Addendum No. 1
June 1, 2020

Project: **Harrisburg Alternative High School Classroom Addition**
Harrisburg, South Dakota

Arch Project No.: 2767

5) SHEET 4.10 – FLOOR PLAN

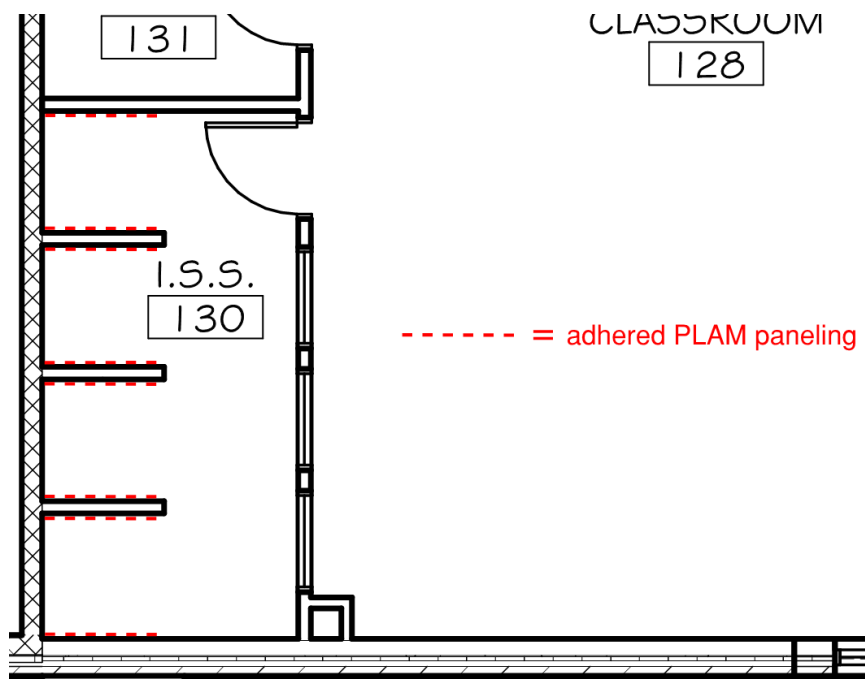
- a) I.S.S. 130 – Adhere plastic laminate paneling to the gypsum board walls on each side of the student desks in room I.S.S. 130.
 - i. The plastic laminate paneling shall be installed to a height of 48” A.F.F.
 - ii. Provide trim at tops and edges of adhered plastic laminate paneling.
 - iii. Plastic laminate color to be selected from plastic laminate manufacturers standard colors/finishes by Owner at later date.
 - iv. Plastic laminate not required at CMU wall at/behind student desks.
 - v. The Wall Finish noted for I.S.S. 130 per the ROOM FINISH SCHEDULE shall be changed to **PLAM/PNT**.
 - vi. Refer to image below for clarification of PLAM extents in I.S.S. 130:
